RE: City of Duluth Bid #11-4403
(New Passenger Terminal Bid Package 2B)

Addendum No. 2

**NEW PASSENGER TERMINAL
DULUTH INTERNATIONAL AIRPORT
DULUTH, MN**

**OVERALL
SECOND FLOOR
PLAN**

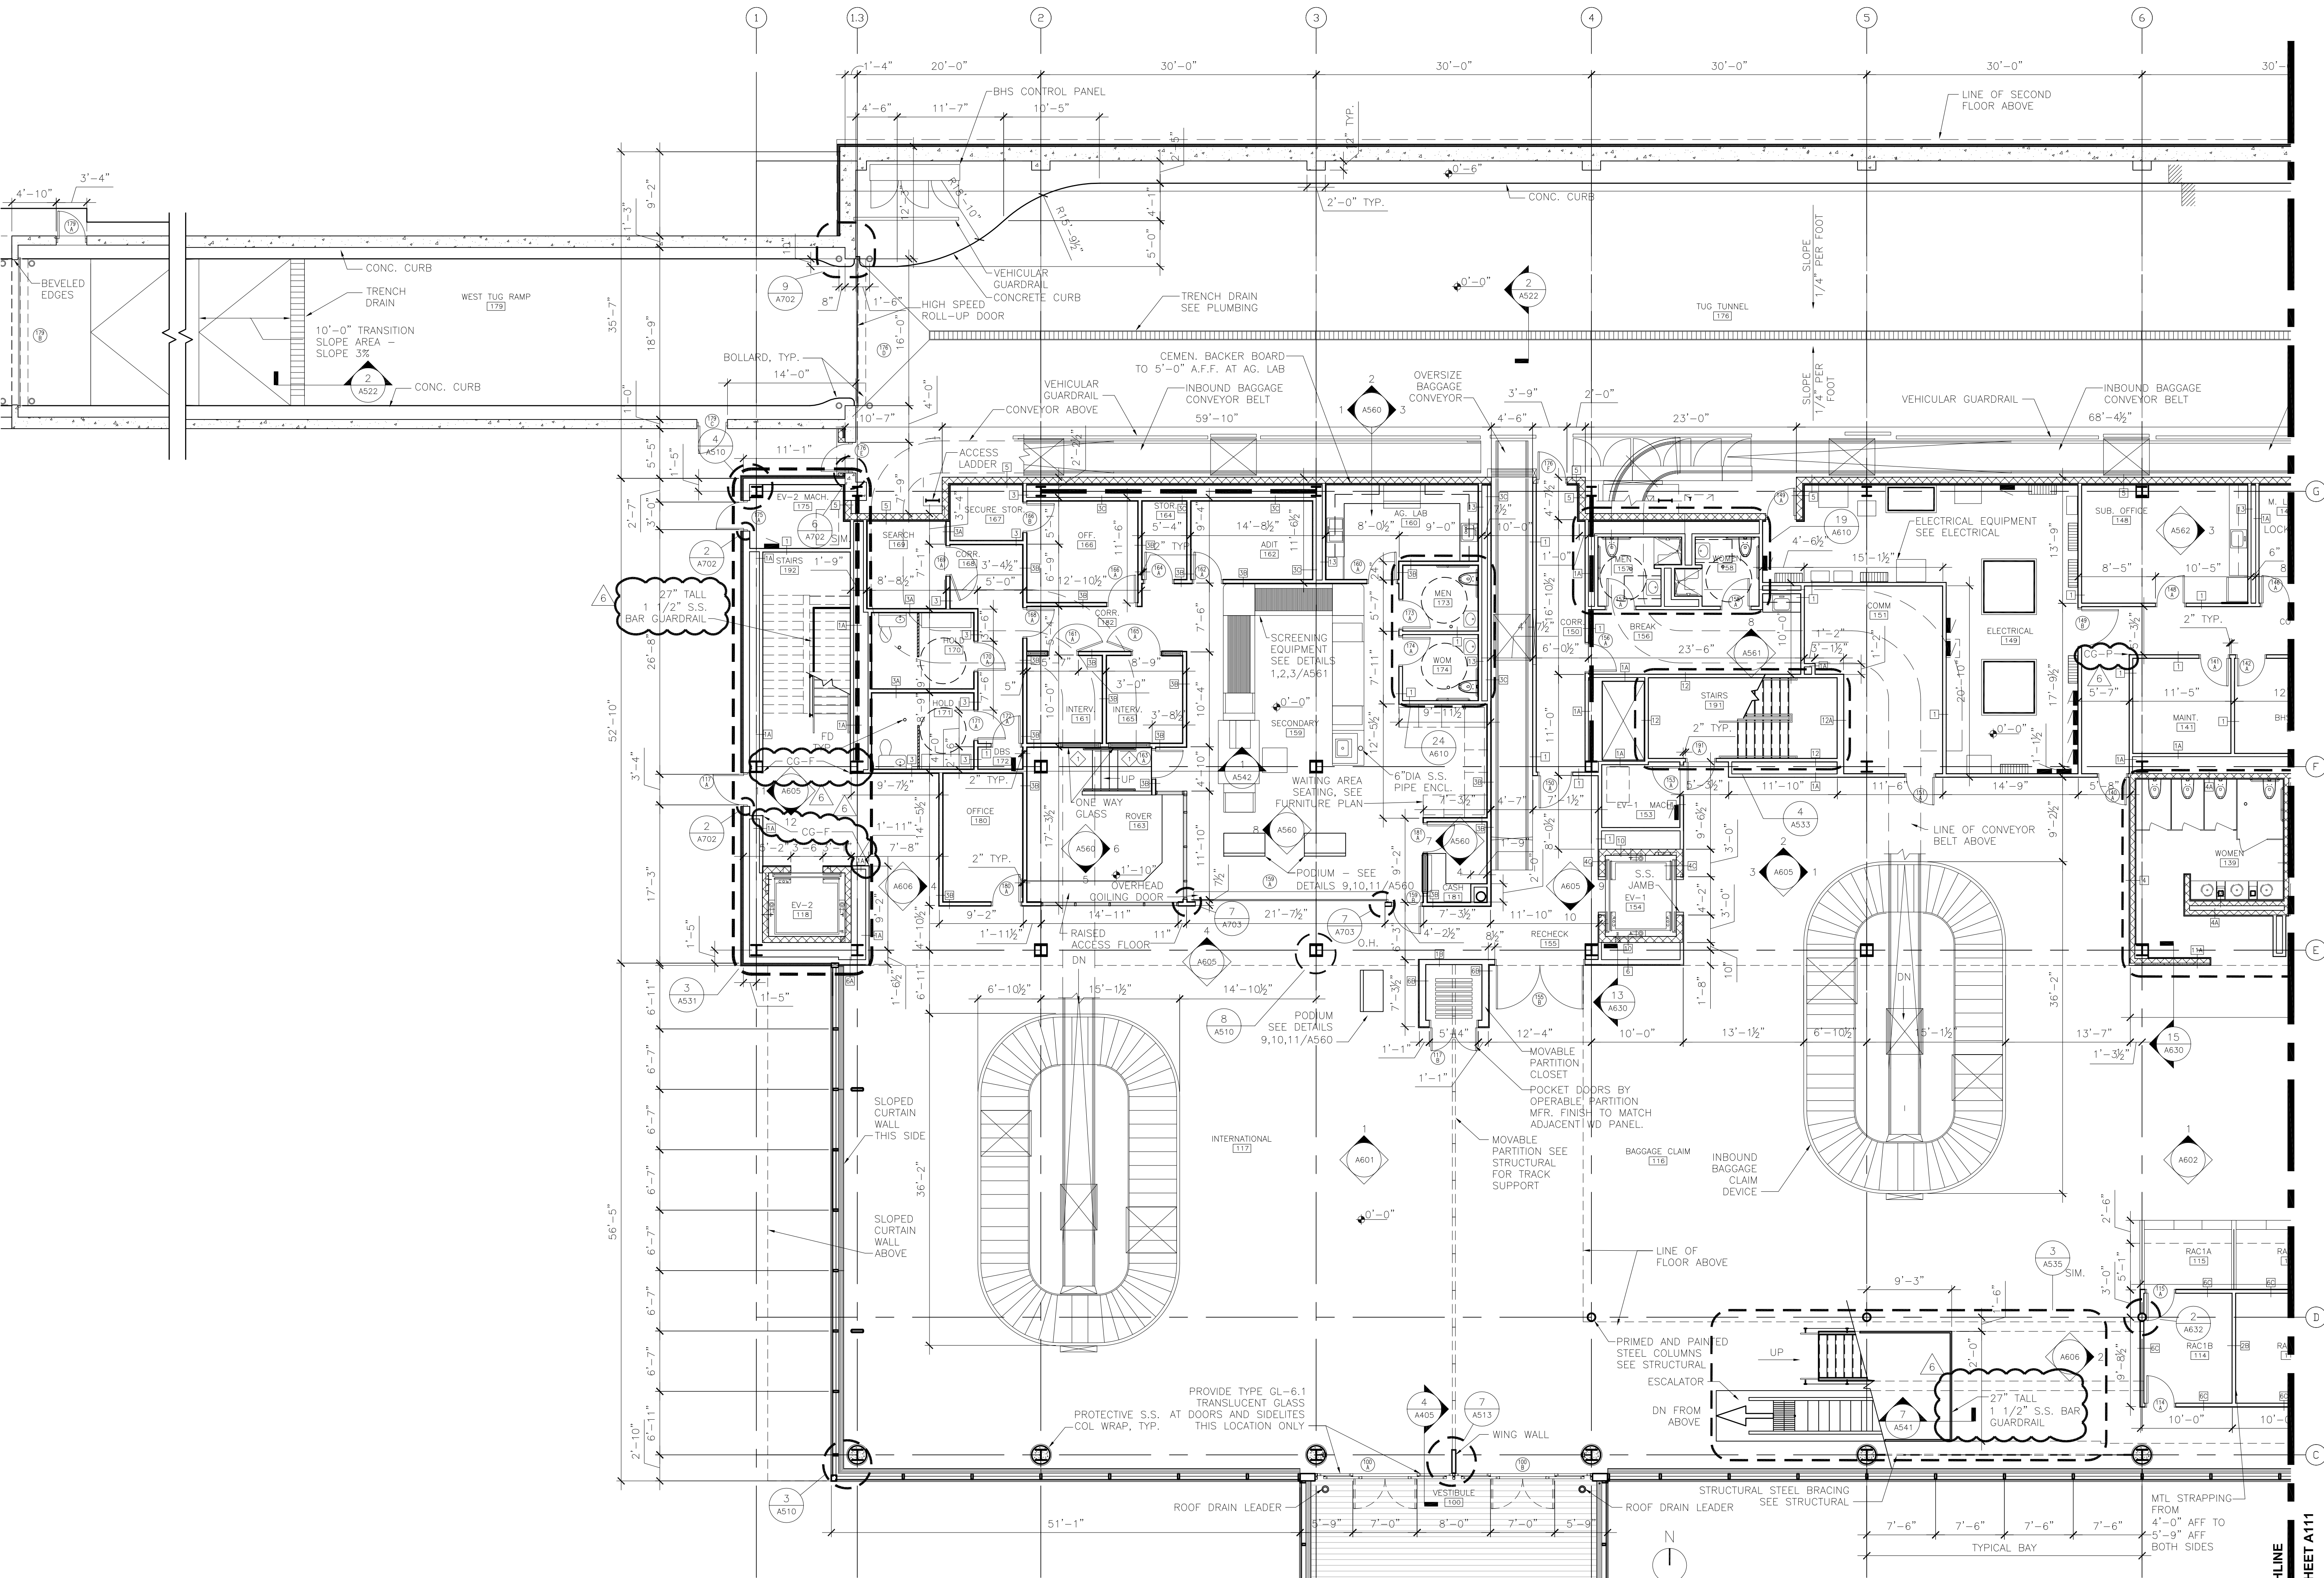
- Sheet A001: Added abbreviations for corner guards.
- Sheet A102: Deleted south canopy.
- Sheet A110: Added corner guards. Revised description of railings beneath escalators.

SHEET NUMBER
A112
**BID PACKAGE 2B
ADDENDUM 2**

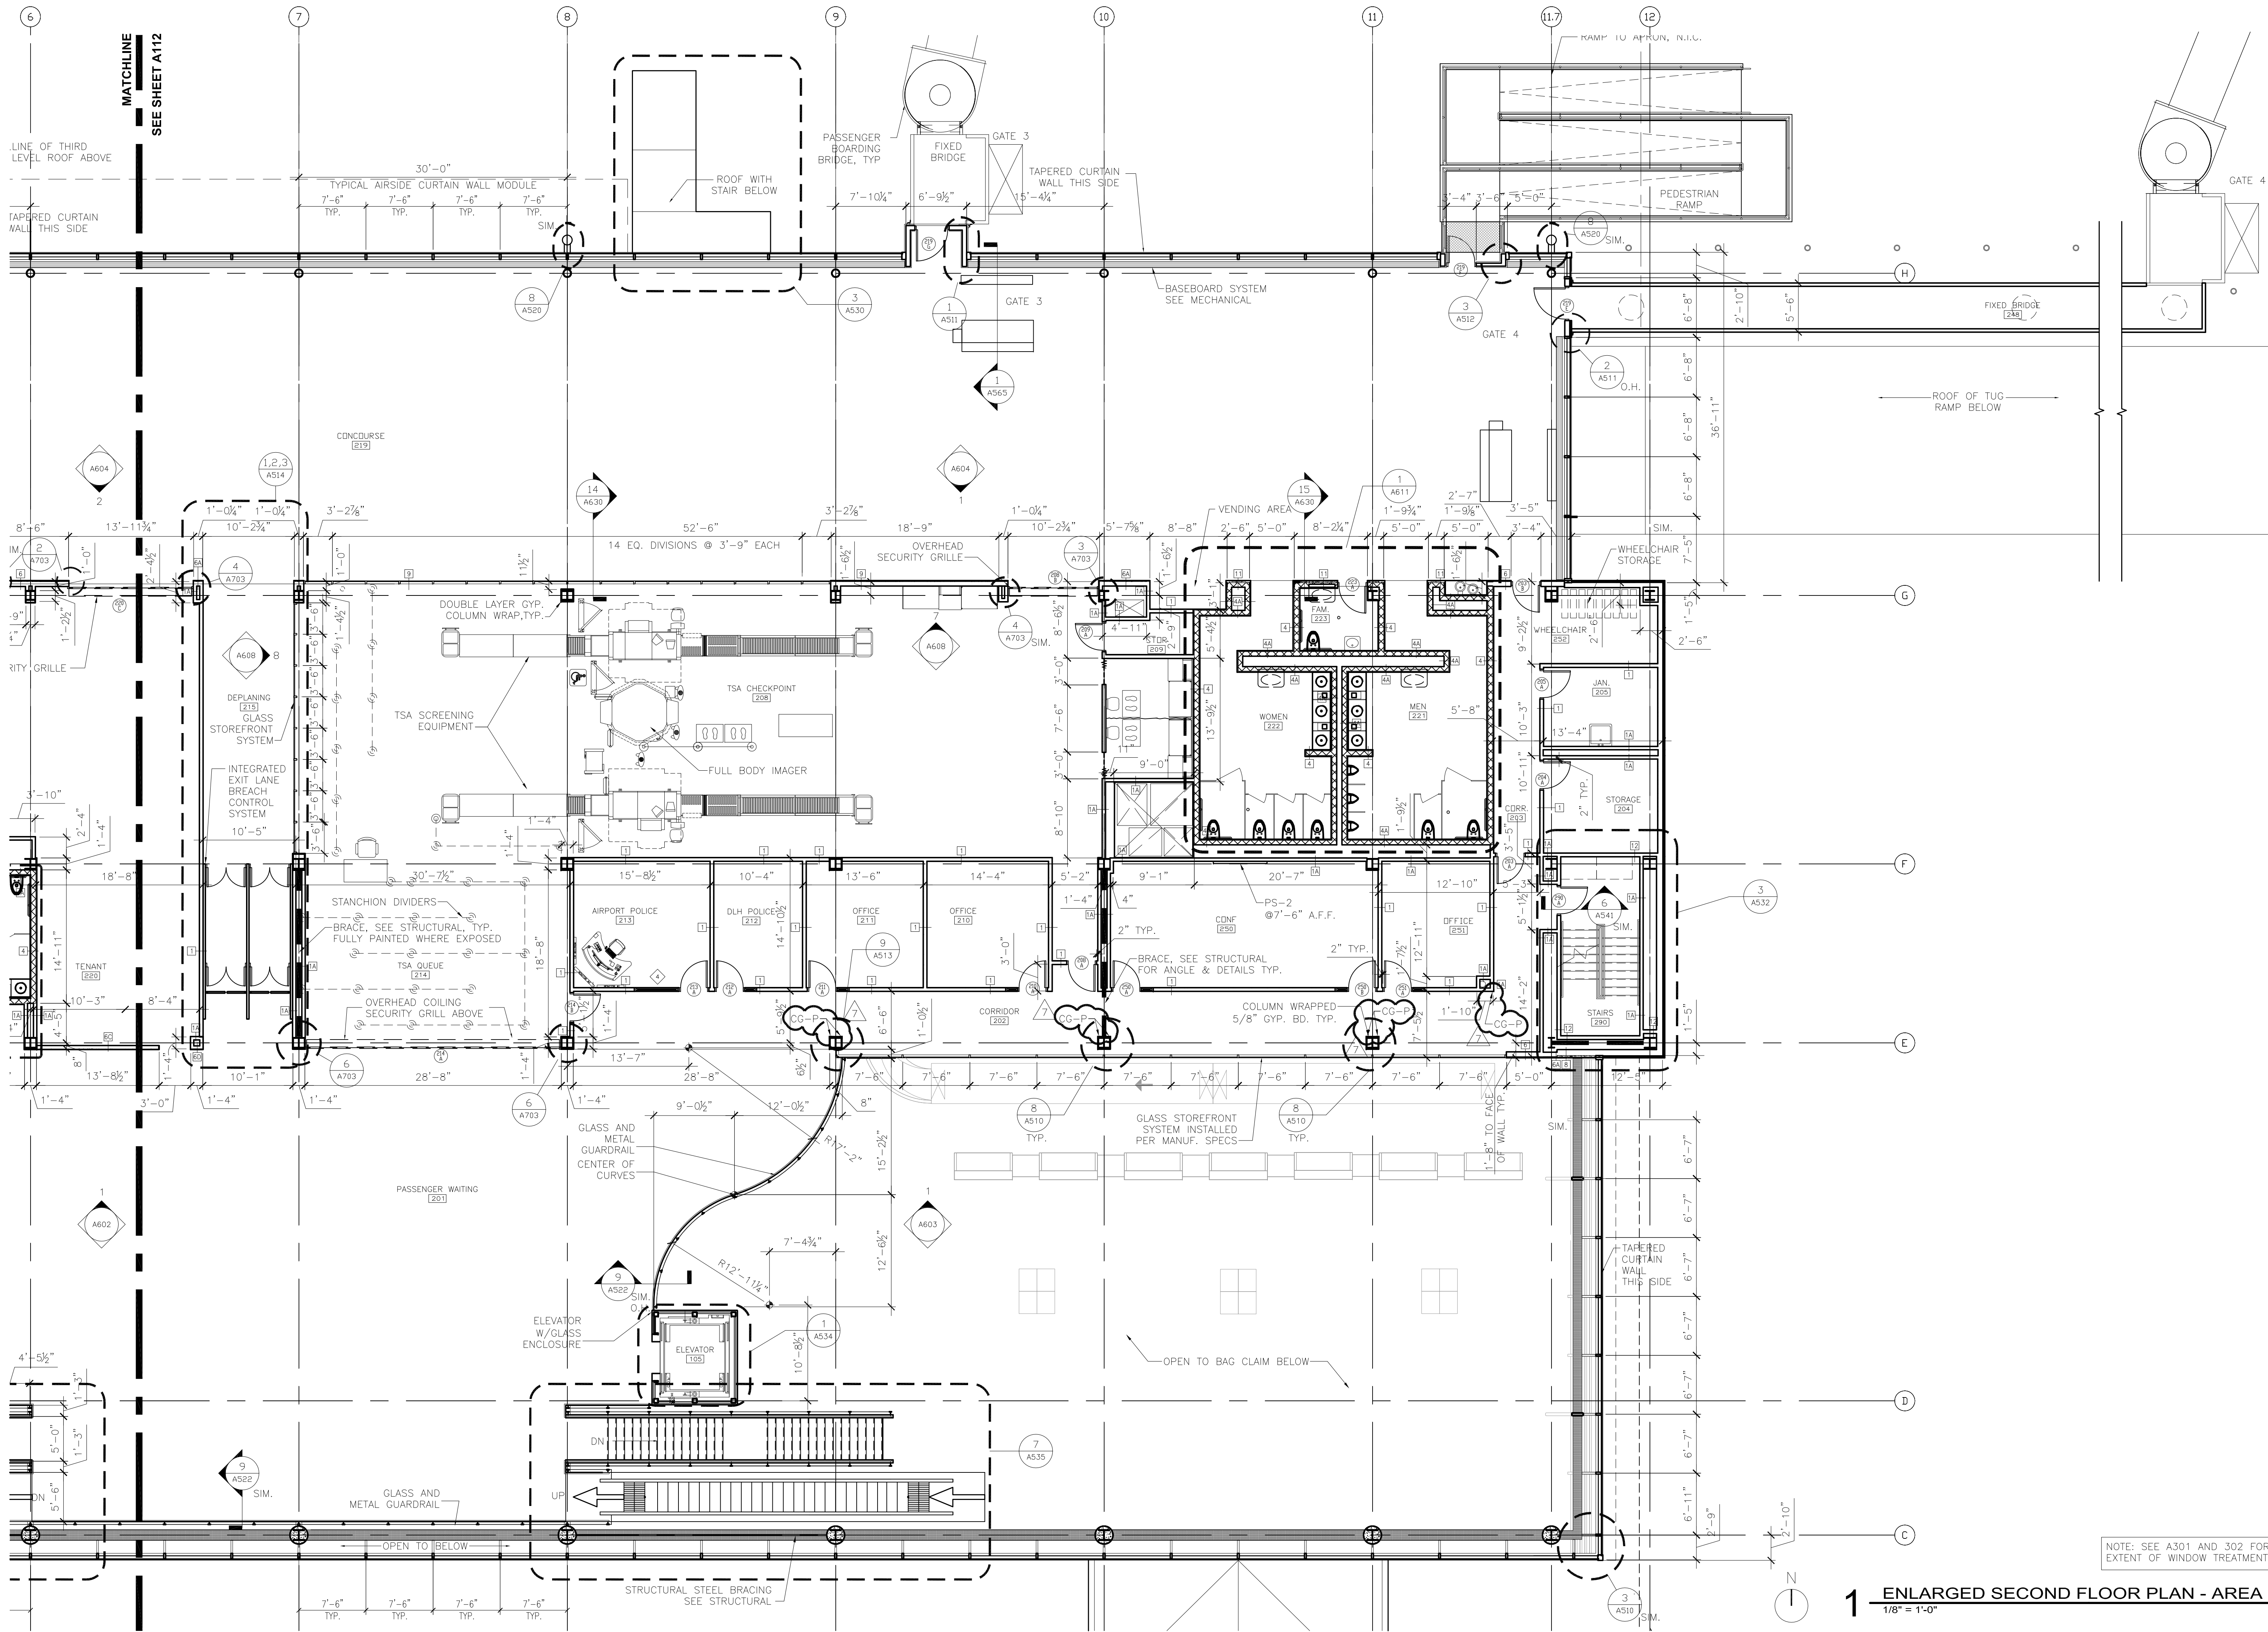
- Sheet A111: Added corner guards. Revised description of railings beneath escalators.
- Sheet A112: Added corner guards.
- Sheet A113: Added corner guards.
